**Re: TransCanada Hydro Northeast Inc.'s July 15, 2016 Updated Study Results Meeting
Summary
Project Nos. 1892-026, 1855-045, and 1904-073**

August 25, 2016 Updated Study Results Meeting Summary

TRANSCANADA HYDRO NORTHEAST INC.
UPDATED STUDY RESULTS MEETING
AUGUST 25, 2016

Stage 2

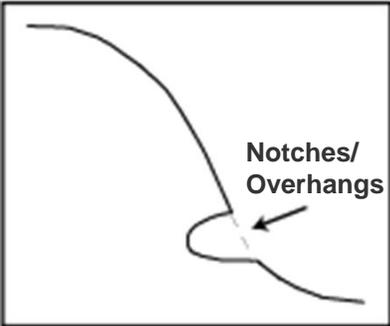
Q: Is notching/overhangs considered not eroding? It would likely continue to erode.

Q [comment]: I just see what I see at my property that the notching continues and is within the normal fluctuation range.

A: Of all the notching we saw, about half was mapped as stable and the other half was otherwise eroding. The process with notching could go either way, either continue to erode or remain stable.

A: The report does say that notching is part of the erosion process and notching has multiple causes. The report shows that much of the erosion occurs far upstream in the impoundments where project dam WSE fluctuations have little to no effect. Project operations do not change WSE in those locations as much as it does closer to the dam or just downstream of the dam. But rates of erosion are higher farther upstream. The study does not pinpoint locations, but characterizes project related effects in the data that we could find and develop. We are not saying the projects do not cause any erosion, but that the continuation of the cycle of erosion is dependent on flood flows that remove the base of bank material.

TransCanada Monitoring Results Site 02-W09 Lyme, NH (Mudge Site) 85

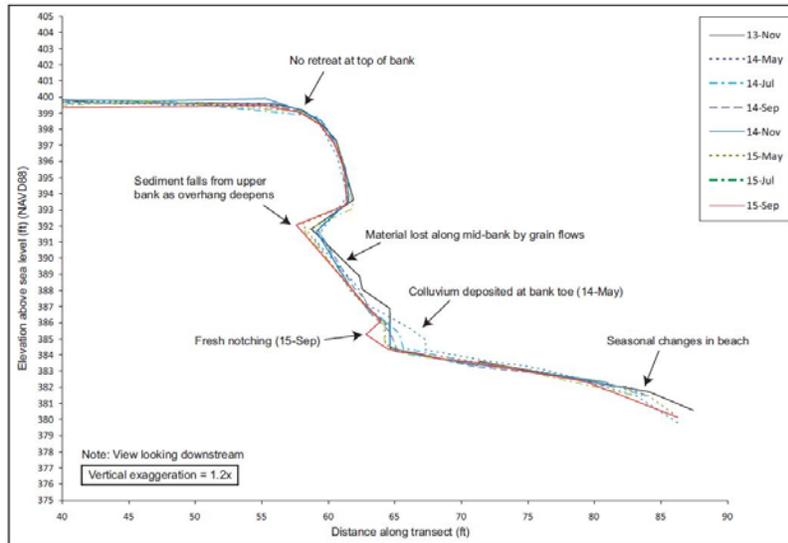
A: The results are based on the available data (1950's and 1970's historical data sets and 2014 field effort for this study). For instance at the Mudge site, there were multiple surveys, so we have those data points but not necessarily at the breakpoints you suggest and not over the entire study area.

Q: The public should know from this report that erosion has caused significant problems in some locations like Lyme. The report shows two places mapped as stable in the appendix where the road is undermined.

A: While we understand the problem and the concern in Lyme, that specific site and causal investigation was not part of the study (e.g., to evaluate hazards to infrastructure) and that area is unusual in terms of erosion with likely causes more difficult to identify. *[Post-meeting note: Our transfer of the historical data into digital form was made from paper maps so the precision is not ideal and not at the scale needed to answer this question. Additionally, the historical maps were likely to have called our vegetated-eroding category "stable" as described in the report and at the meeting. Once we know the exact locations of road undermining via GPS, we will look at the 2014 mapping data and relevant photos more closely to determine if there may be a discrepancy.]*
